# DEPOT REMOVES AND REPLACES

THE ARMY HAS MADE A CHANGE TO THE SOURCE, MAINTENANCE AND RECOVERABILITY (SMR) CODES OF THE FOLLOWING PARTS USED IN THE AN/APX-118(C) TRANSPONDER SET, NSN 5895-01-504-0407...

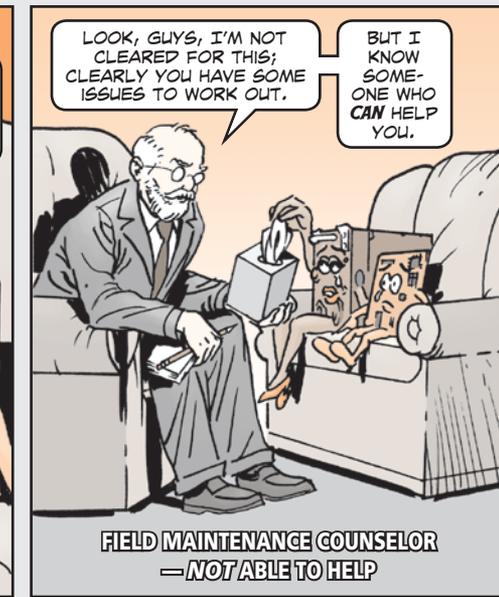
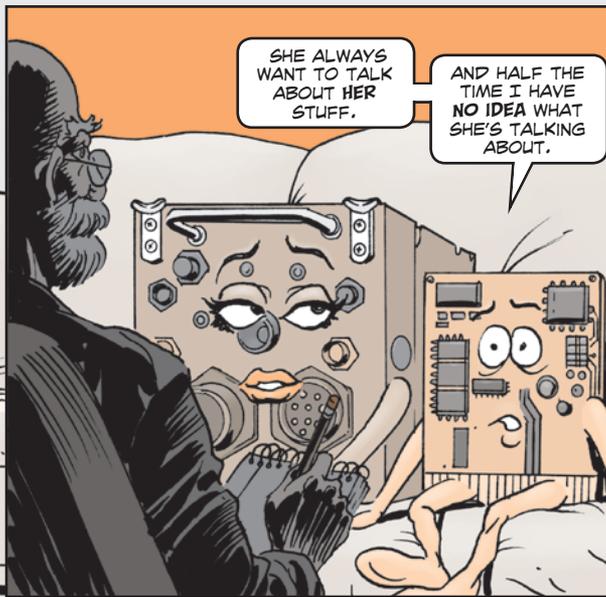
The specific change is to the maintenance code, 3rd position. Field maintenance is no longer allowed to remove and replace the parts. From now on, only depot maintenance is allowed to remove and replace them. So, make a note in the RPSTL of TM 11-5895-1733-13&P (Jun 04) until the TM is updated to show the maintenance code has changed to D for these items.

Change maintenance code, 3rd position, to D

(1) ITEM NO.	(2) SMR CODE	(2) NSN	(4) CAGI COD	(1) ITEM NO.	(2) SMR CODE	(2) NSN	(4) CAGI COD
1	PAFD	5975-01-512-7961	8024	1	PAFD	5975-01-512-7961	8024
2	PAFDD	5998-01-510-5897	8024	2	PAFDD	5998-01-510-5897	8024
3	PAFDA	N/A	8024	3	PAFDA	N/A	8024
4	PAFDD	5998-01-510-5853	8024	4	PAFDD	5998-01-510-5853	8024
